Selwyn District Plan, Private Plan Change 76 – Dunweavin 2020 Limited, 605, 617 and 627 East Maddisons Road

Joint Officer Summary Statement, Selwyn District Council

FIGURE 1: APPROVED SUBDIVISION LAYOUTS, OPD AREA 10 AND PC76

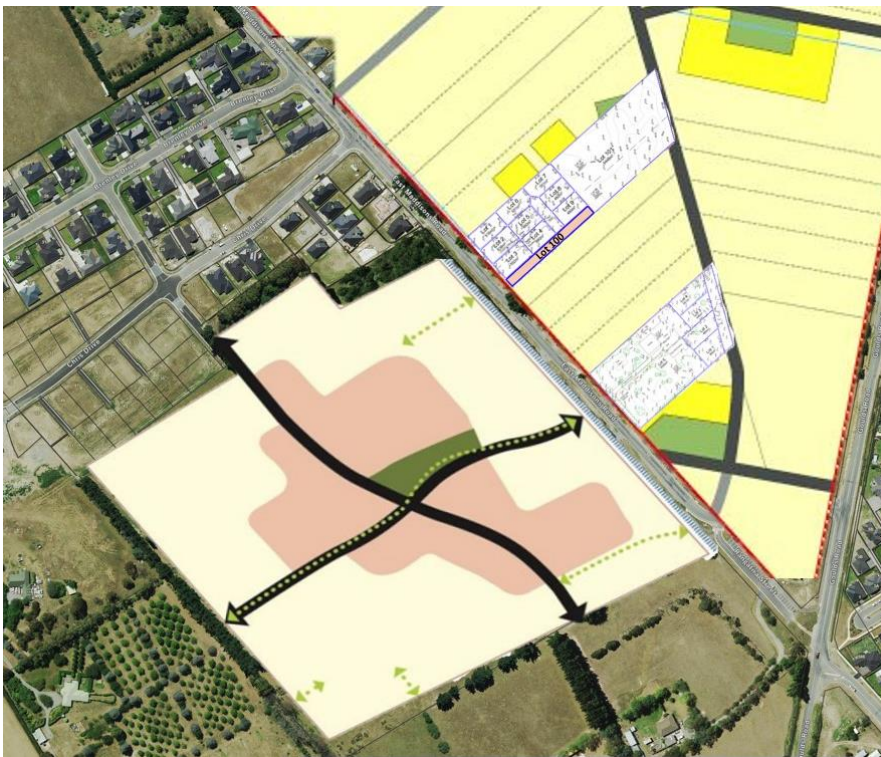
b. The ODP and Policy B4.3.77 are amended to align the primary road network within PC76 with the roading network established in the subdivisions on the opposite side of East Maddisons Road. c. The ODP and Policy B4.3.77 are amended to illustrate a more direct east to west aligned road through the site.	The plan change proponent has amended the ODP to address this recommendation.	<div> <input type="checkbox"/> Agree <input type="checkbox"/> Neutral <input checked="" type="checkbox"/> Disagree/further comments </div> <div> Comments - Mat Collins, Transport In response to Ms. Williams Transport evidence regarding the alignment of the proposed east to west road, Mr. Collins has overlaid the updated ODP with the approved subdivisions on the eastern side of East Maddisons Road, both with and without ODP 10 overlaid (refer to Figures 1, 2 and 3 below). Lot 100 of one of the granted subdivisions (RC215566) includes a 9m wide vested road. The intention is that this is to be widened to a full width road when the neighbouring site is subdivided. Lot 100 is also likely to be extended to Rufus Street when Lot 101 is subdivided in the future. </div>

Mr. Collins recommends that the “secondary road” on the PC76 ODP is realigned to form a crossroad intersection with Lot 100 and 632 East Maddisons Road to create a better-connected transport network.
